DESIGN COMMISSION

Agenda Item #2: DSR19-007 Study Session

STAFF REPORT

North Mercer Pump Station (NMPS) Upgrade

8. SAMPLES OF MATERIALS

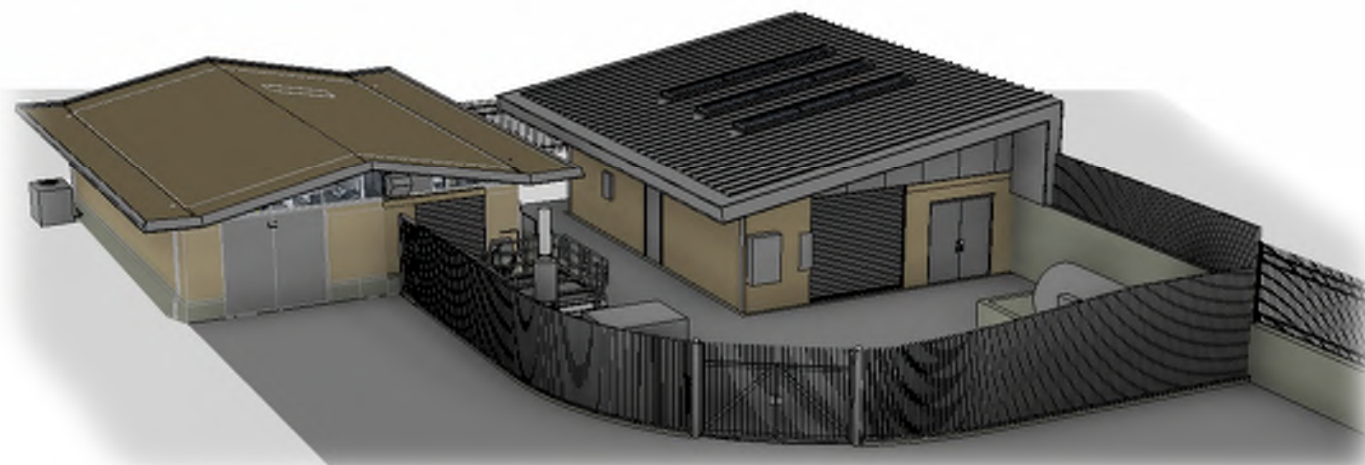
The example screening fences are proposed to be made from ornamental metal (Exhibit 1, page 37 of 37), complementing the building materials, which also include metals of a variety of textures (Exhibit 1, page 29 of 37). Metal is also one of the preferred materials listed in MICC 19.12.040(B)(3)(b). Renderings show the proposed fence height as being approximately 6 feet in height, which is consistent with the visual character of the neighborhood, meeting the standard in MICC 19.12.040(B)(3). However, note that fences required by state law to enclose public utilities are exempt from fence height standards in residential zones pursuant to MICC 19.02.050(G).

10. LANDSCAPING AND TREE REMOVAL PLANS

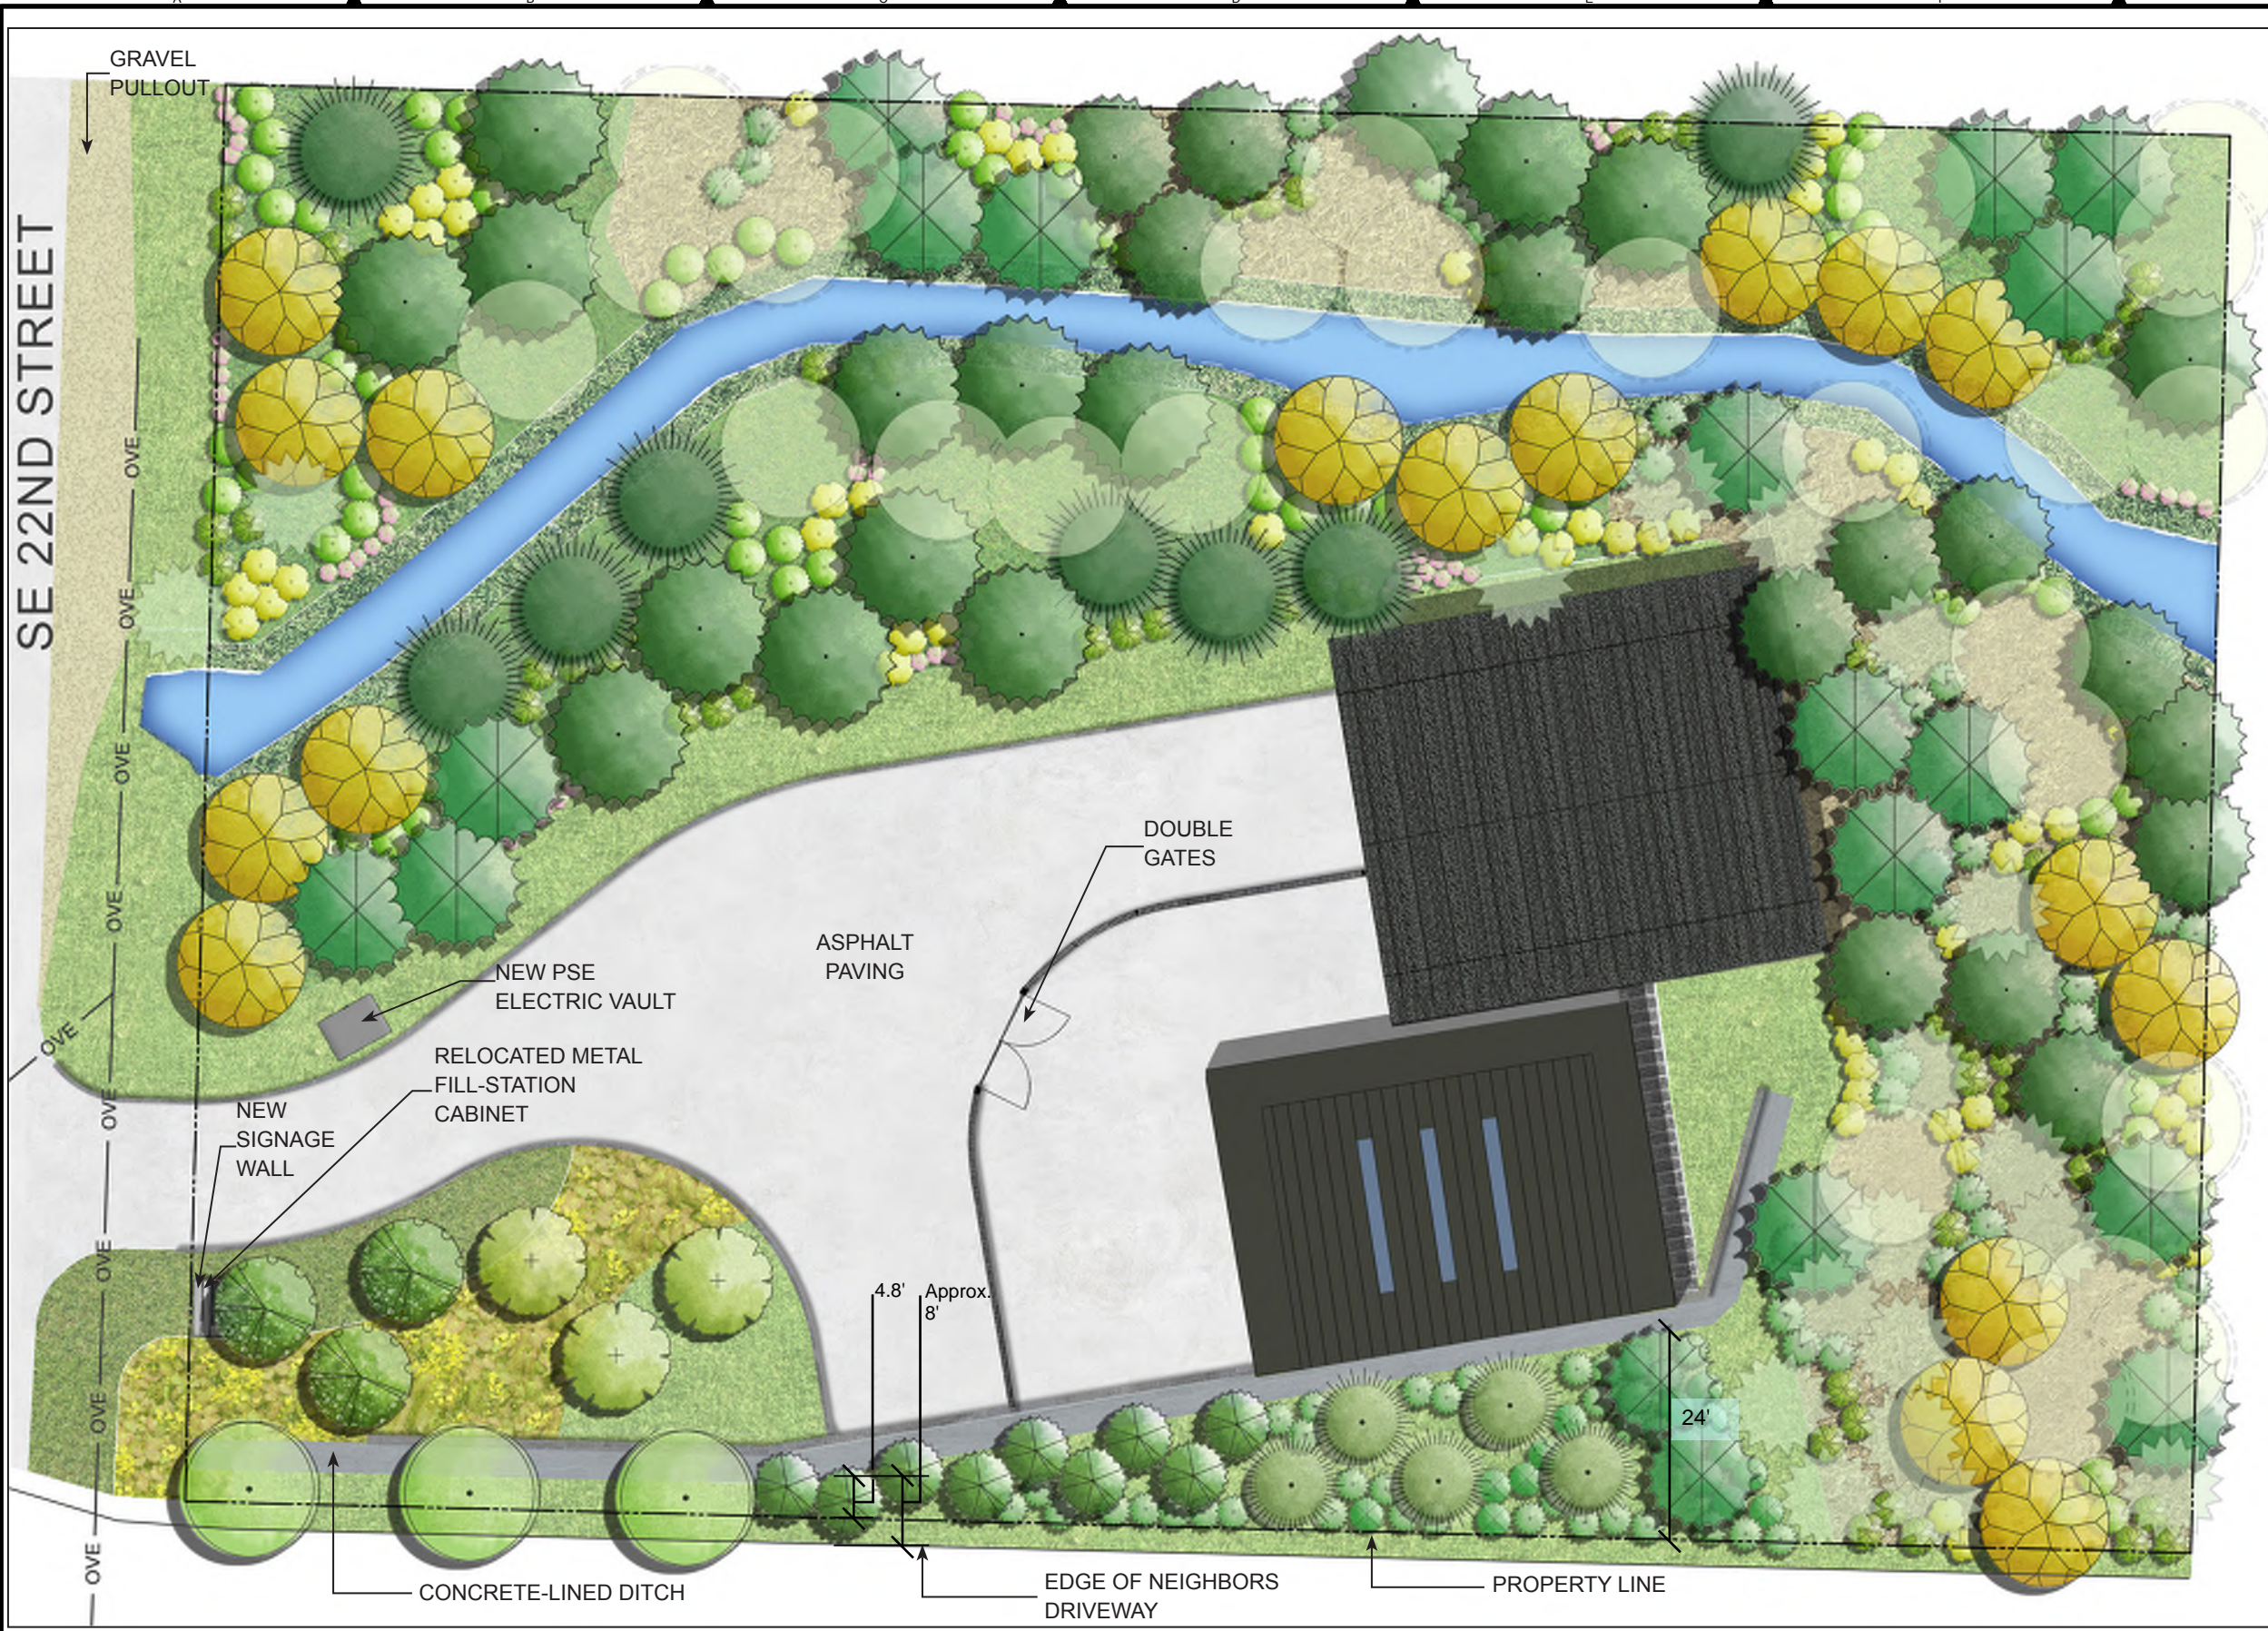
1. Applicant Question #1: Discuss options for meeting required landscape screening width along western property line. We are also considering a more decorative panel wall in this area that could be combined with landscaping to provide more of a visual barrier. See question 3 below.

The landscaping plan submitted for the study session shows 4.8 feet of landscaping between the proposed concrete-lined ditch and west property line (Exhibit 1, page 32 of 37) at a pinch point, less than the 20-foot standard. However, the use of the term "should", when used in MICC 19.12, means the standard is mandatory unless the applicant can demonstrate, to the satisfaction of the design commission or code official, an equal or better means of satisfying the standard and objective (see MICC 19.12.010(E)).

Staff analysis: Landscaping standards are listed in MICC 19.12.040. MICC 19.12.040(B)(7) addresses landscape screening widths and states that 20 feet of full screening should be installed when a Utility (for example, the pump station) is adjacent to a residential use, as is the case for the subject site. "Full screening" means a full screen should block views from adjacent properties as seen at the pedestrian eye level in all seasons within three years of installation (MICC 19.12.040(B)(8)(a)).
